## BW750 – Steel/Elastomer cylinder head gasket for Rover K series engine

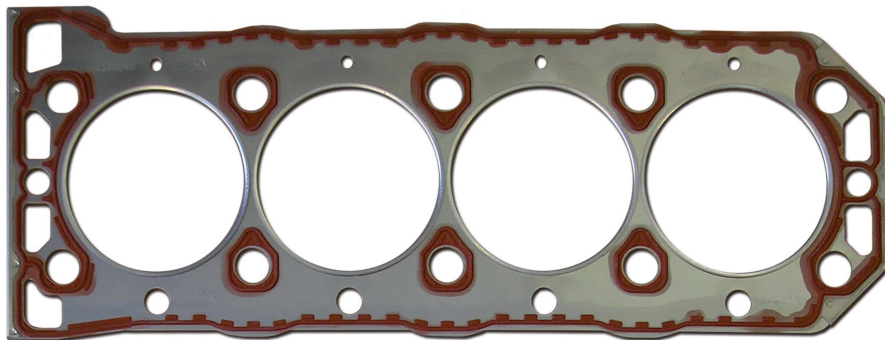
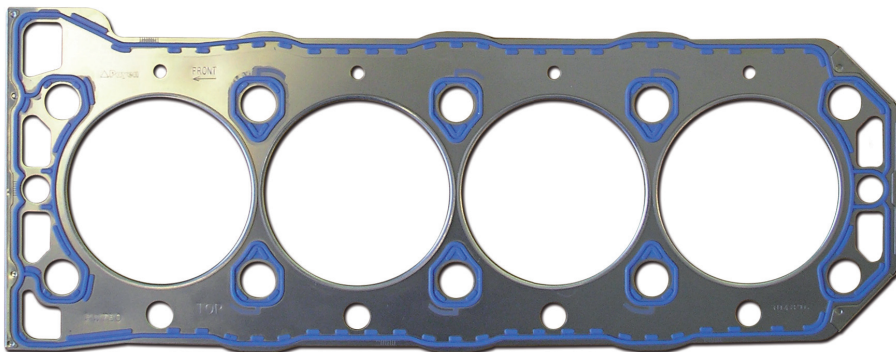
Please note that this gasket which was supplied as Original Equipment to Rover and Land Rover before the introduction of the MLS version BW5750 will, due to new manufacturing specifications, change in appearance.

In line with current OES supply, Federal-Mogul will now provide this gasket with a **BLUE silicone Selected Area Coating (SAC)**. The new specification will be supplied on a rolling change basis as existing stocks with a RED silicone SAC are exhausted throughout all distribution networks.

**C30 BLUE silicone is OE Engineering approved** and this 'cosmetic' only change also brings BW750 into line with other Federal-Mogul Steel/Elastomer gaskets using C30 silicone, such as the PSA XUD9 and DW10 engines.
